BEKO FLAVEL	SERVICE BULLETIN		Bulletin no	2007-06	Date	09.03.2007
	Prepared by	Yaşar CEYLAN	Signature			
	Approved by	Ibrahim YILDIRIM				
TECHNICAL EXPLANATION OF THE CHANGE

DOOR HOOD RUBBER (WMA510/520)

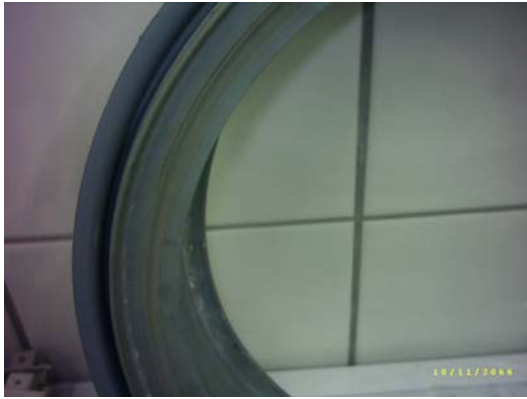
Door hood rubbing against steel drum at various spin speeds causing a burning rubber smell or slight smoking.

First check whether the stainless steel drum is coming in touch with the door hood rubber at any point of the circumference

During examination of the door hood rubber if there is sign of rubbing through 180° or 360°, the Door Hood Rubber should be replaced with the replacement part, Part Number 2812380100. If the new Door hood rubber is in contact with the steel drum this will not be a problem.

After fitting the new part, load the machine with laundry and softener then run the rinse and spin programme.

During the test run check the washing machine for a rubbing noise or burning rubber smell.
